# Value Planning

## Draft of Final Report

### Elwha River Water Quality Mitigation Project

September 20, 2000

Figure 3. Municipal Water Storage Proposal

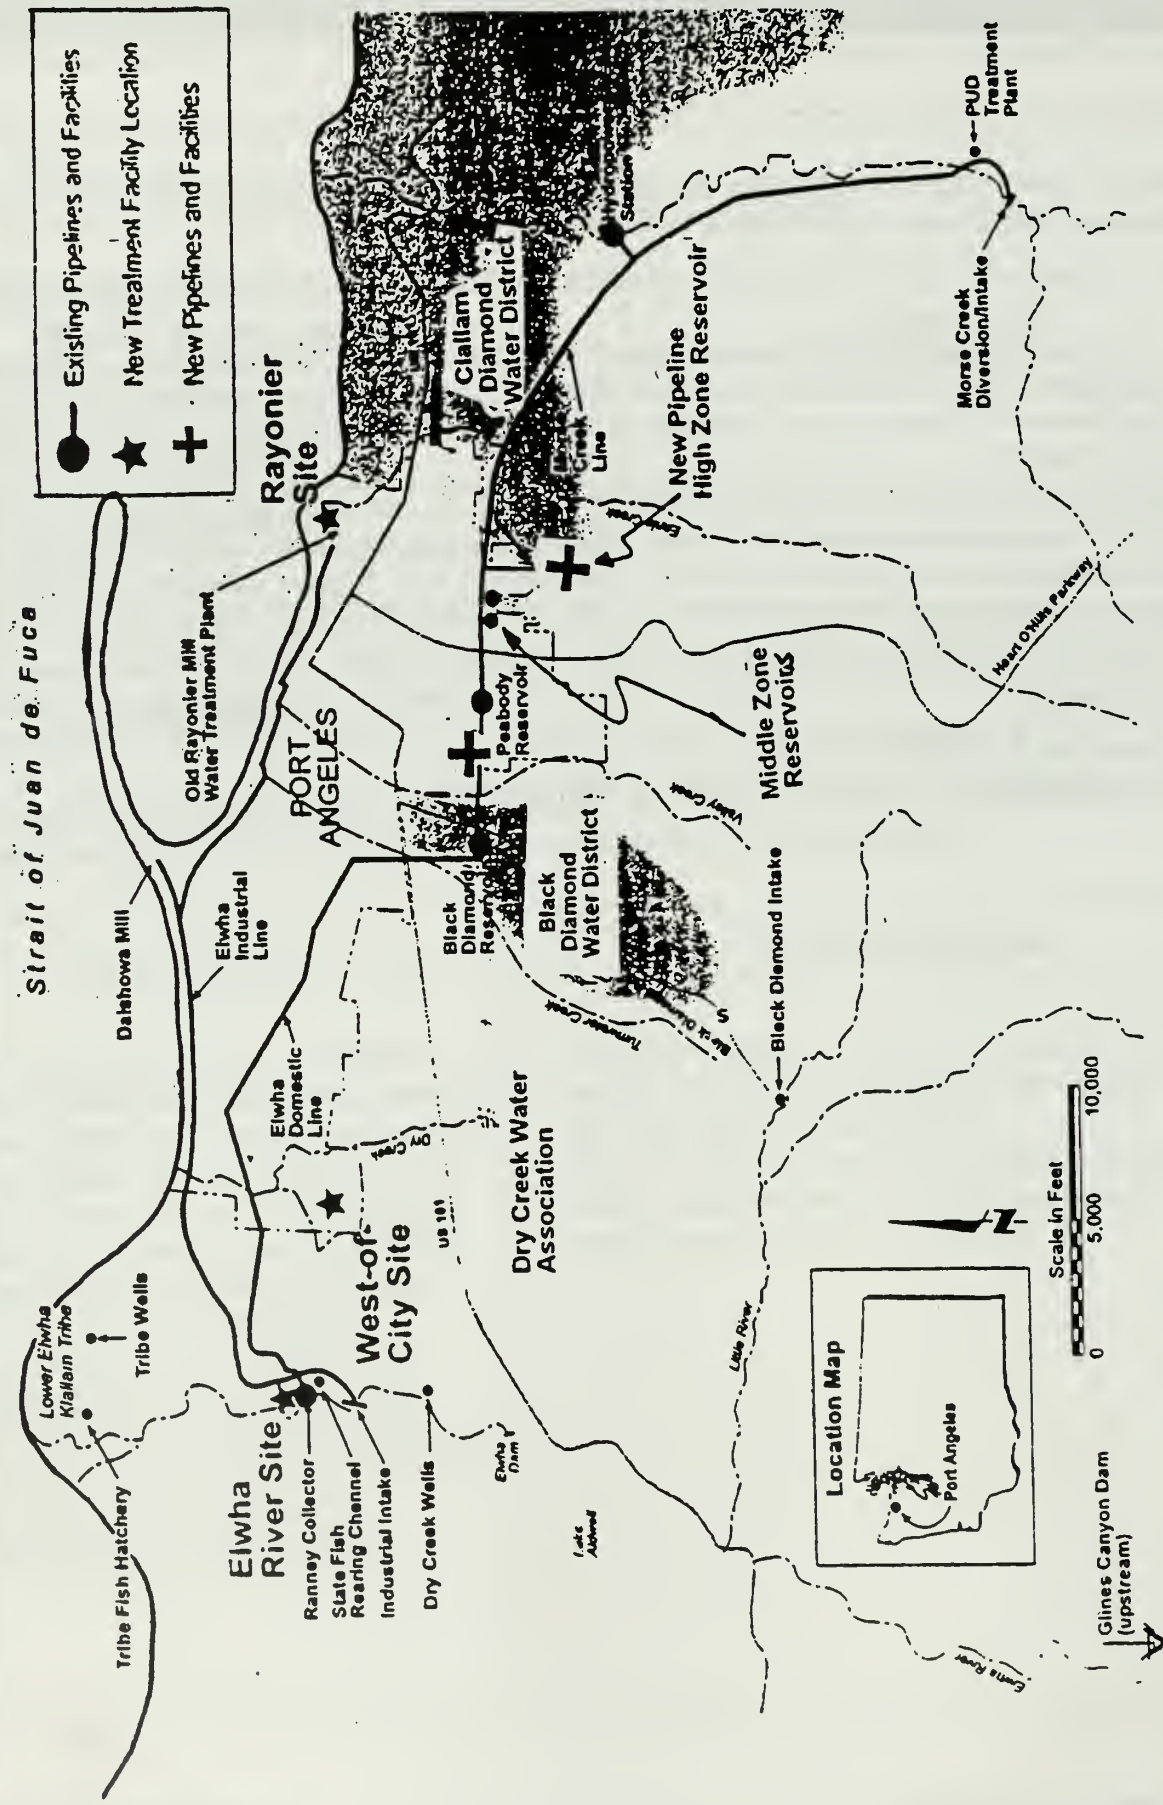
- Proposal Description: Construct treated water storage for the City of Port Angeles.
- Critical Items to Consider: This proposal can be implemented in conjunction with the industrial-water storage proposal. It was not considered in the Elwha River Ecosystem Restoration IEIS. A supplemental EIS may be necessary.

- Ways to Implement: To avoid issues associated with high-sediment concentration days, water would be pumped from the city's existing Ranney Well during low-sediment concentration windows, treated, and transferred to three 10-million-gallon storage facilities. Two storage tanks would be constructed in the city's middle pressure zone and one facility would be constructed in the high-pressure zone. This proposal would provide sufficient storage to provide a five-day supply during high-sediment events that will occur during dam deconstruction. See Figure 3.

Figure 4. Pilot Schematic

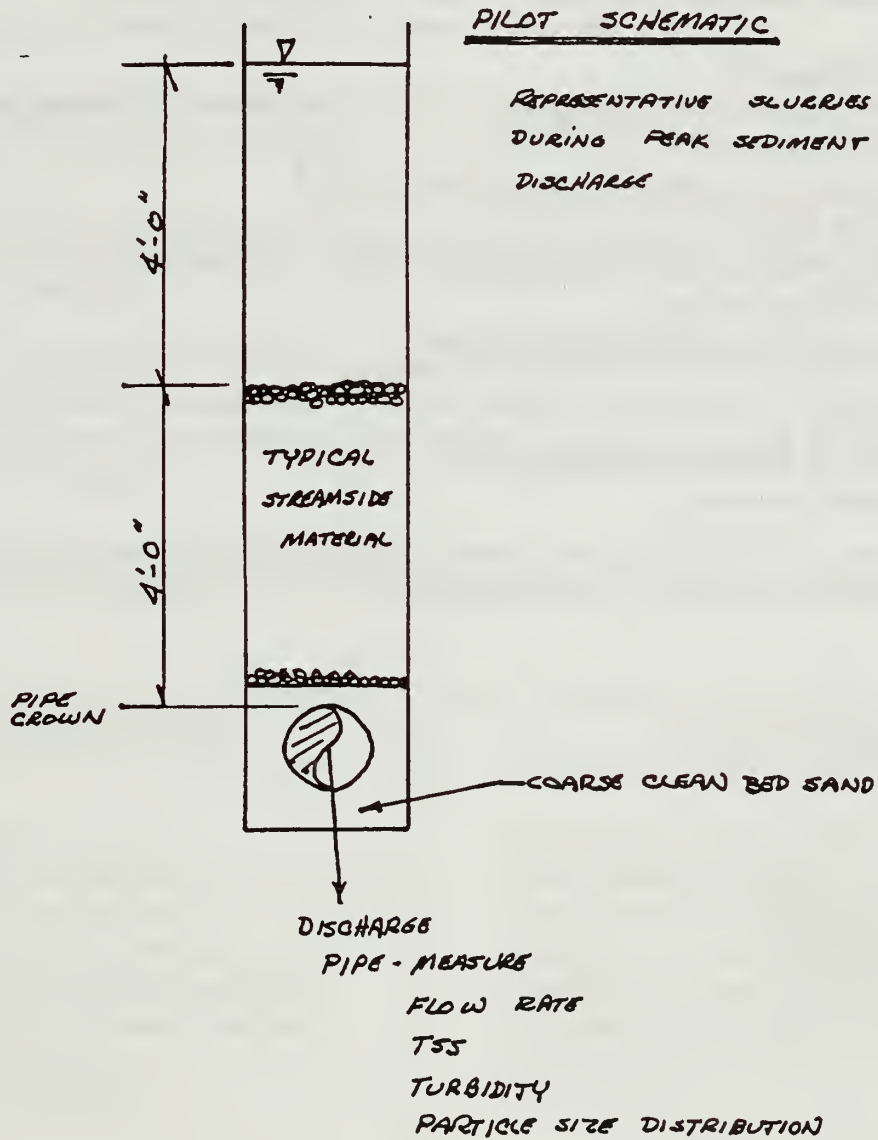
- Proposal Description: Infiltration gallery pilot testing.
- Critical Items to Consider: Sample location/character, Total Suspended Solids (TSS) comparable to anticipated quality, assess performance versus risk.
- Ways to Implement: Establish laboratory and sampling apparatus. See Figure 4 and Table 1.
- Changes from the Baseline Concept: No bench scale testing is provided in the baseline concept.

### **Set up column per Figure 4**

**Make up 4 slurry concentrations using sediment ranging from 1,000 to 40,000 mg/l TSS**

- Measure the following parameters at constant head**
  - Flow rate verses time**
  - Influent/effluent (filtrate) TSS at beginning, middle, and end of run**
  - Turbidity per TSS as above**
  - Particle size distribution of feed and filtrate**
- Backwash Testing**
  - Backwash with 10 percent of filtered flow**
  - Evaluate flowrate recovery**
